Access Compliance Report

Public Rights-of-Way

(Pedestrian Signals)

Intersection ID: N/A	Main Street:	Cross Street: N/A	Location: N/A
ADA ID: 90EFEAAAB863	Signal Type: One Push Button-Non APS	Overall Compliance: No	Severity Score: BTN 1: N/A BTN 2: N/A No BTN: N/A
Codes/Mitigation Info/Possible Solution		Field Measurements/Component Compliance

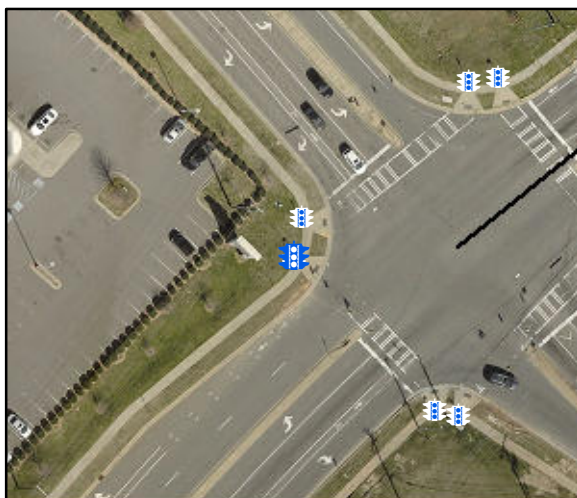
PROW/ADA: TMUTCD 4e.08, R406.2

Possible Solutions: Replace Signal Push Button With APS Button on New Post. Remove & Relocate Sign.
